In re Application of)
)
PANUNTO, John P.)
)
Serial No: 10/660,533) Art Unit: 3653
)
Filed: 09/12/2003) Examiner: **MORRISON, Thomas A.**

For: **LARGE CAPACITY BOTTOM FEED DISPENSER**

RESPONSE TO OFFICE ACTION DATED 01/03/2006

Fig. 3

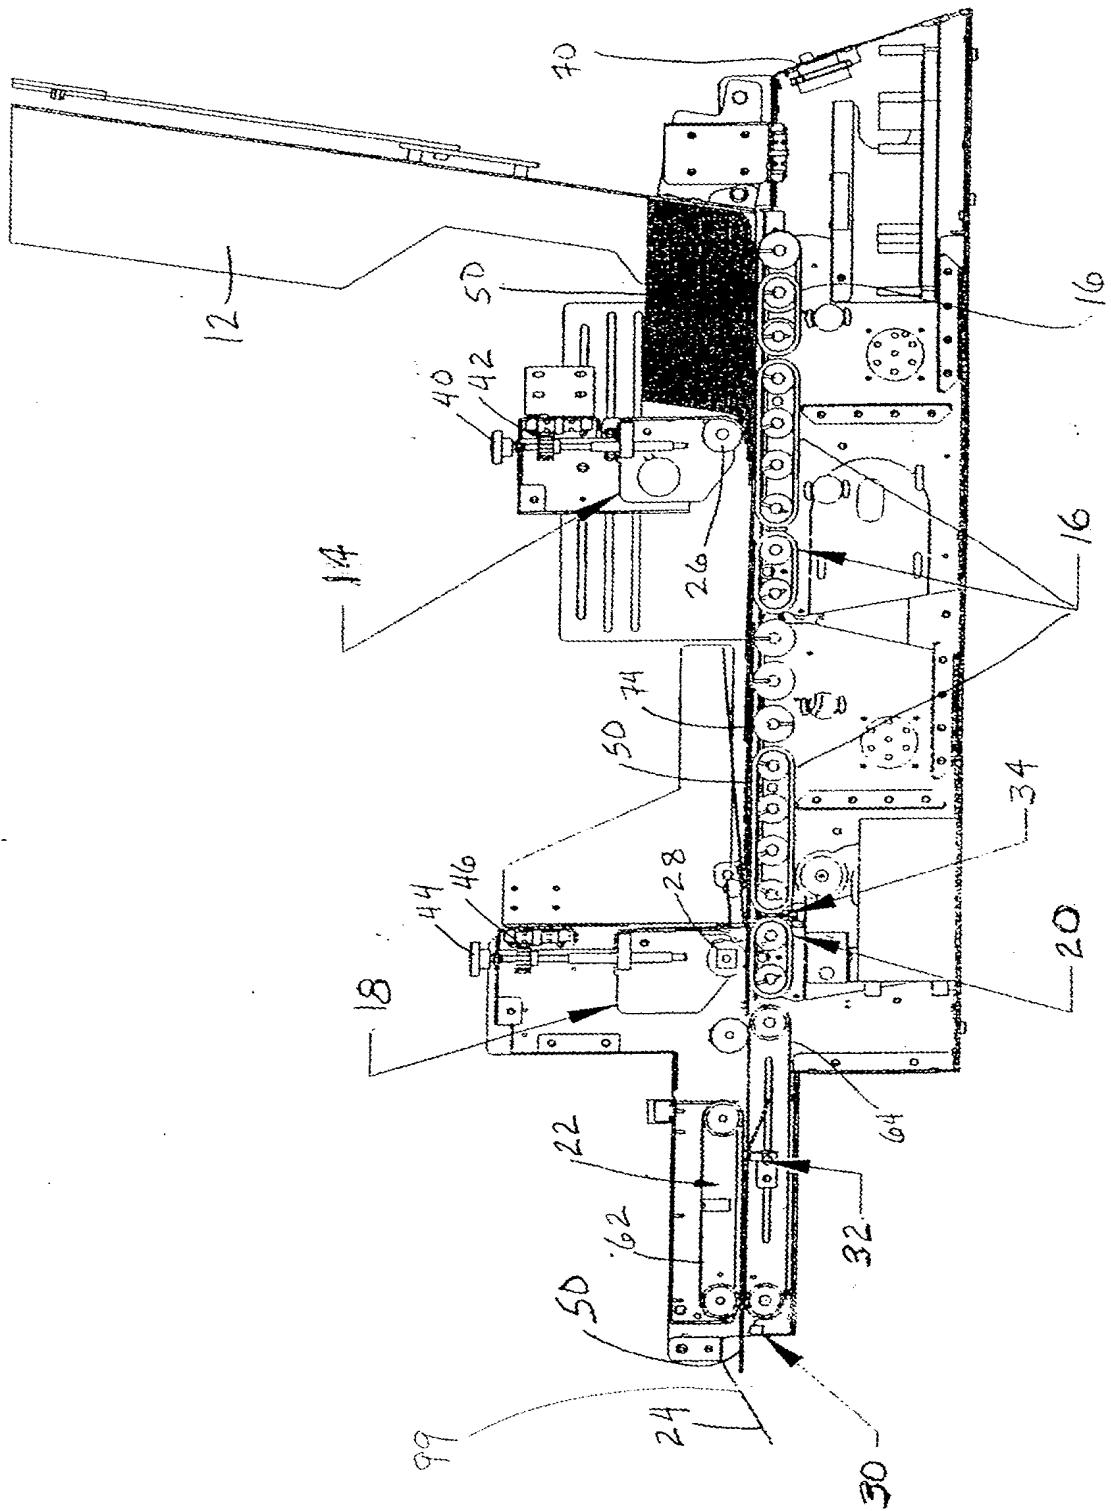
The attached sheet of drawings includes changes to Figure 3. This sheet replaces original Figure 3.

The drawings were objected to because of the reasons set forth in section 1 of the Office Action. In response, Figure 3 has been amended to remove reference character 22 pointing to the axle of the transport conveyor. Figure 3 has also been amended to label the location of the box ready sensor 99. In a related amendment, paragraph [0054] has been amended to identify the “box ready sensor” as --box ready sensor 99--. In view of these amendments, it is respectfully submitted that the drawings are now in proper form, and withdrawal of the objection to the drawings is requested.
